Out of Order:

An evaluation of the regulatory aspects of Los Alamos National Laboratory's
proposal to vent tritium from waste containers

Prepared for Tewa Women United, Santa Cruz, New Mexico

November 2024

Figure 1: Comparison of LANL 2019, LANL 2020, and Franke 2024 dose estimates for a 32,000 curie release at the White Rock receptor location with long-term and December 1, 2018 daytime weather data.

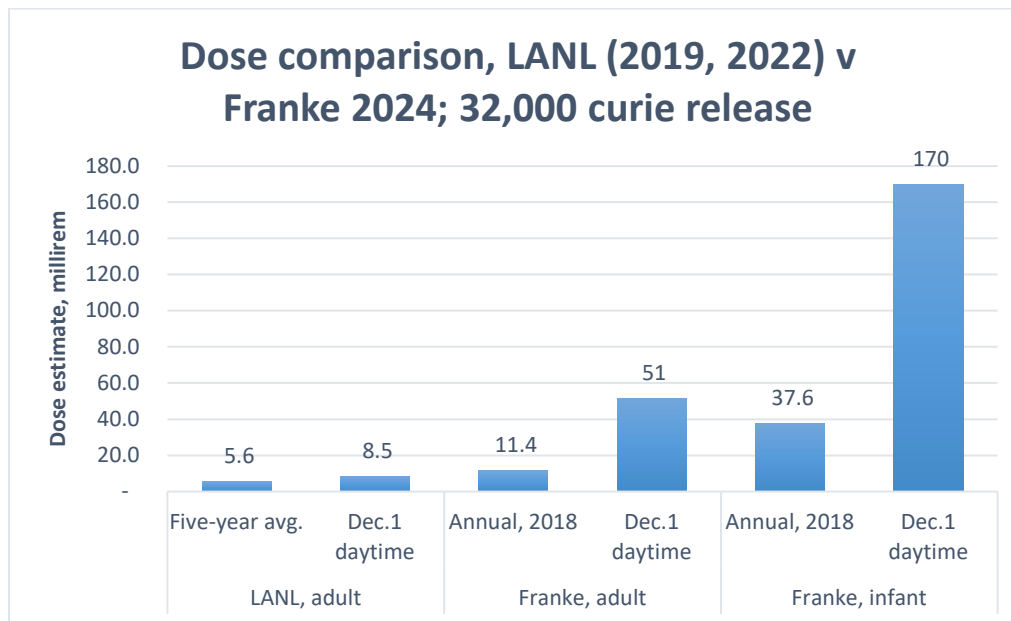
Figure 1 compares the LANL 2019 annual dose and LANL 2020 revised "bounding" dose for December 1 with the results in Franke 2024 using 2018 annual and December 1 daytime data.

A part of the reason for the lower December 1 LANL dose estimate is very likely due to a higher humidity assumption made by LANL. But this does not explain most of the discrepancy.

While a definitive comparison between the LANL 2020 “bounding case” estimate and Franke 2024 is not possible because LANL has not published the complete information needed to do that, the following conclusions can be drawn:

- **Dose limit:** Even if LANL’s dose factor of $2.66E-4$ mrem/Ci is accepted, the 40 CFR 61.92 dose limit would be violated for an infant member of the public as well as children who are older – for instance, for one- and five-year olds.
- **Humidity:** The LANL use of annual average humidity is scientifically incorrect for a “bounding case.” LANL’s use of long-term average 2018 humidity means that its “bounding case” dose would underestimate the dose by 50% or more (depending on which year it used).
- **Dose factor:** The LANL dose factor for an adult for the 10-hour period on December 1, 2018 is likely to be significantly underestimated.
- **Bounding case:** Given the above analysis, LANL’s dose factor of $2.66E-4$ mrem/Ci is unlikely to be a bounding case for adults; it is not the bounding case when all members of the public, including children, are considered.
